# Exhibit I:

December 11, 2013

Re: Major Comprehensive Plan Application No. NE-12-022

Transmittal Number X254064 - Salem Harbor Redevelopment (SHR) Project Responses to Comments on Draft PSD Permit and Proposed Air Quality Plan Approval

Figure 4-1. CO<sub>2</sub> Pipelines in the United States

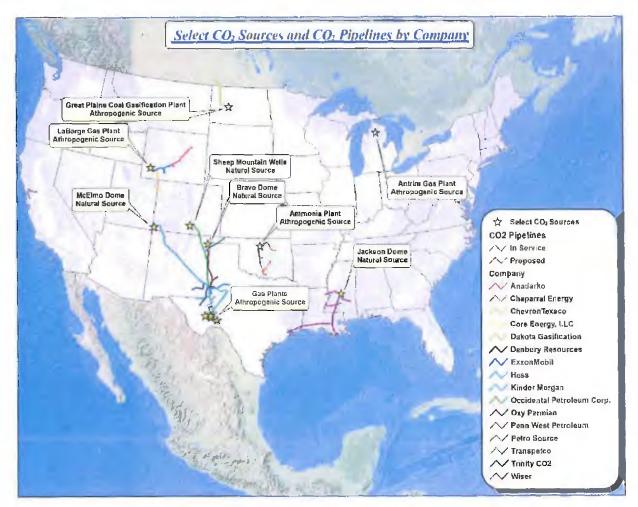
Regarding pipeline transport for CCS, there is no nearby existing CO<sub>2</sub> pipeline infrastructure (see Figure 4-1); the nearest CO<sub>2</sub> pipelines to Massachusetts are in northern Michigan and southern Mississippi. With regard to storage for CCS, the Interagency Task Force concluded that while there is currently estimated to be a large volume of potential storage sites, "to enable widespread, safe, and effective CCS, CO<sub>2</sub> storage should continue to be field-demonstrated for a variety of geologic reservoir classes" and that "scale-up from a limited number of demonstration projects to widescale commercial deployment may necessitate the consideration of basin-scale factors (e.g., brine displacement, overlap of pressure fronts, spatial variation in depositional environments, etc.)".
